HEARINGS EXAMINER MEETING AGENDA
Wednesday, July 10, 2019, 5:00 PM
City Hall, 616 NE 4th Avenue

- A. Public Hearing for the Lacamas View Residential Care Facility Conditional Use Permit (CUP18-02)
Presenter: Lauren Hollenbeck, Senior Planner

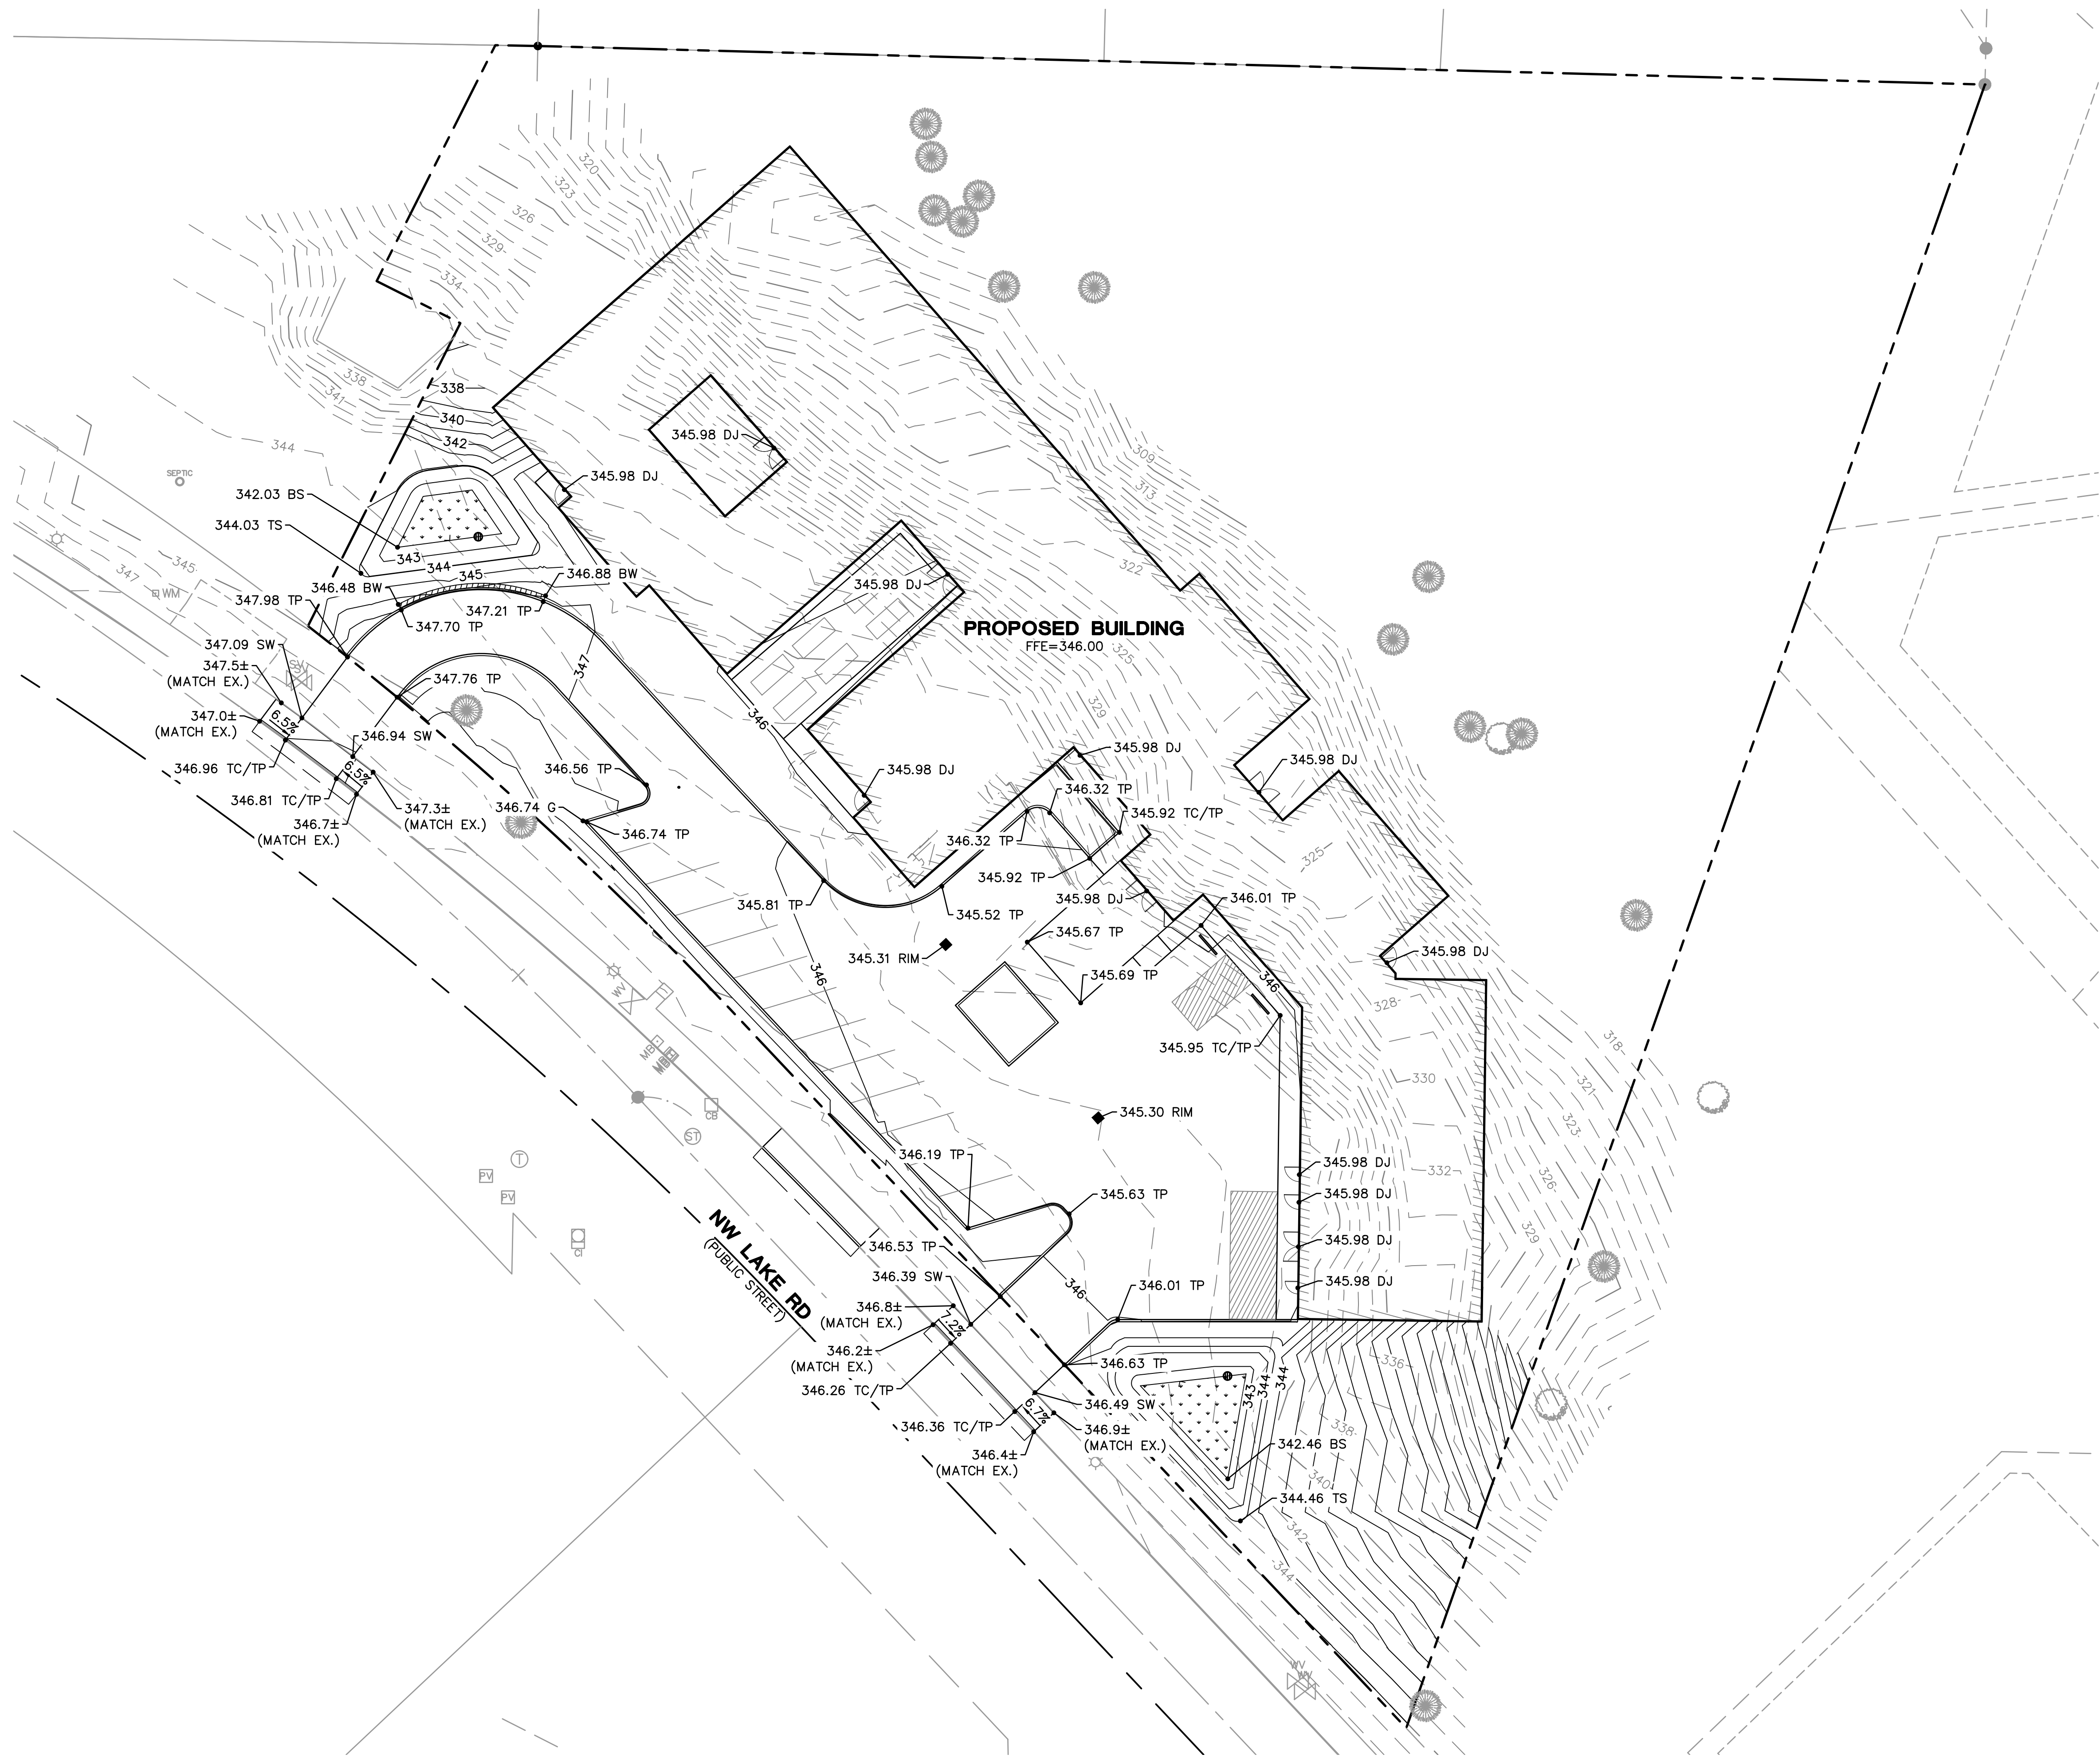
4. In the RSS report, there are several areas where the slopes on the property are described. The steepest slope in the report is noted as 40 percent (i.e. less than 2H:1V). However, we have checked slopes on Sheet 2.0 and it appears that some of the slope immediately south and north of the private graveled driveway north of the existing house (labeled as "SE 122nd Ave (P)" on Figure 2 of the RSS report) is oversteepened (i.e. greater than 50 percent, or 2H:1V). We recommend that RSS re-check the site slopes and update their report as necessary. They should pay particular attention to identifying oversteepened slope areas on the property greater than 50 percent. This is important because Sheet C2.0 shows the new building will be supported by foundations bearing on the slopes north and south of the private drive.

5. RSS states in their report (page 3) that the forested, descending slope northeast of the private drive will remain unaltered. This does not appear to be accurate based on Sheet C2.0. It appears construction will encroach onto that lower slope below the private drive. RSS should review this and revise their report as necessary.

Figure 3: Subject site, 2016 aerial image, 2-foot contours, approximate proposed new building location and approximate boring locations

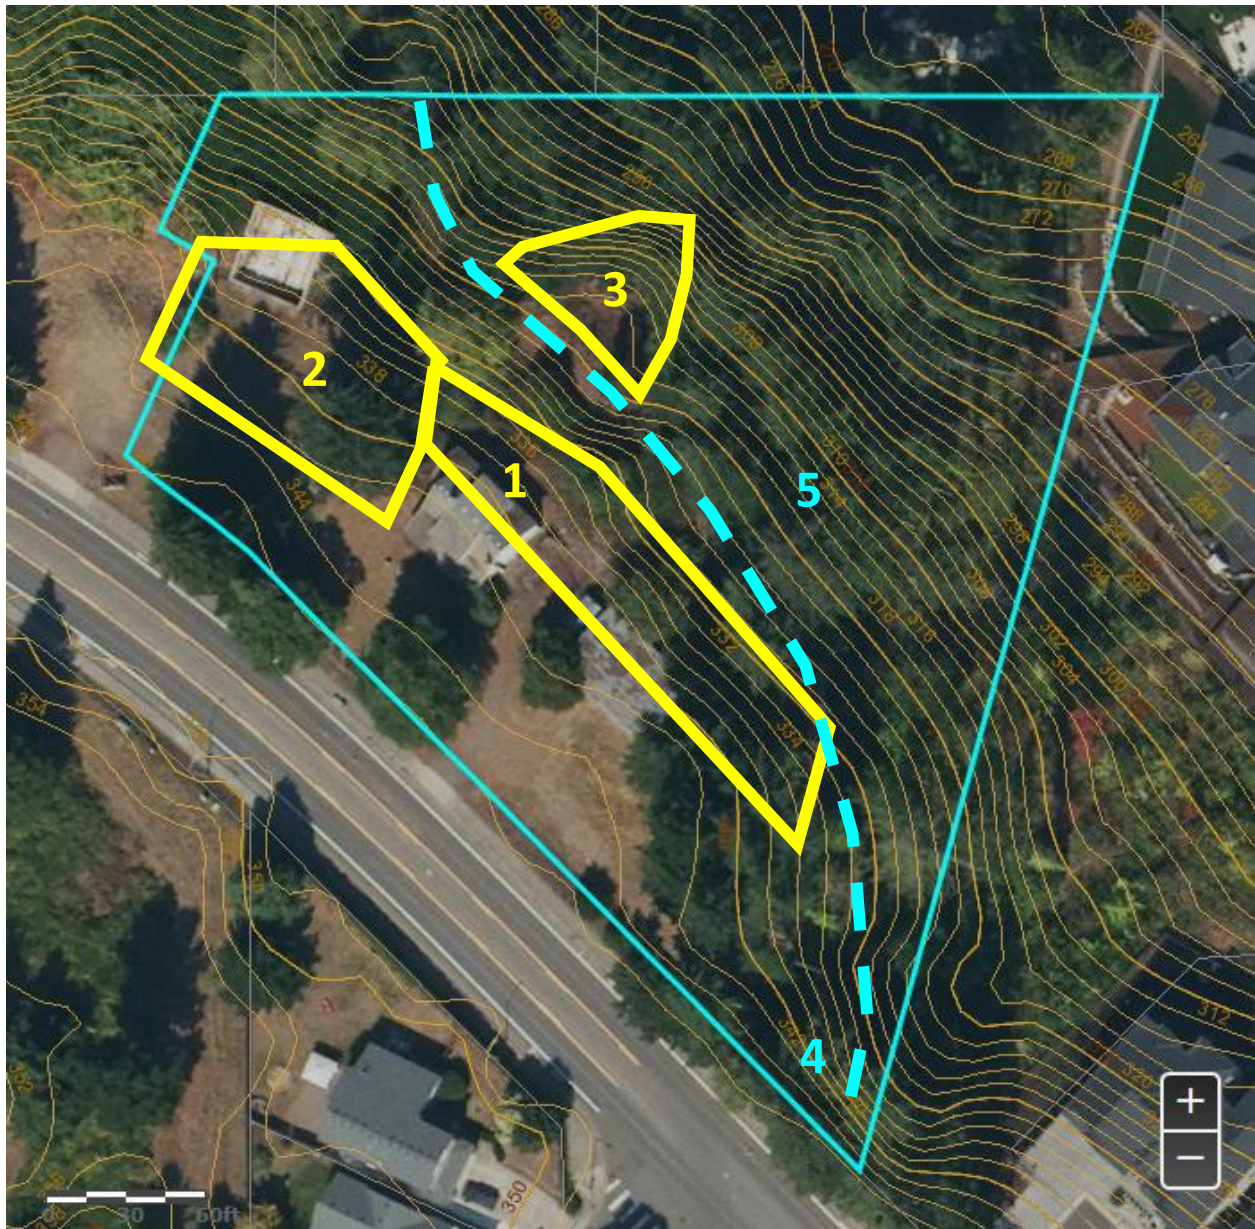
16. Based on Figure 3 in the RSS report, it does not appear that any explorations were performed on the downhill side (north) of the existing private graveled drive. This is significant because some of the new building’s footings will be located on that steep slope. We recommend RSS consider performing additional explorations that evaluate that particular slope.
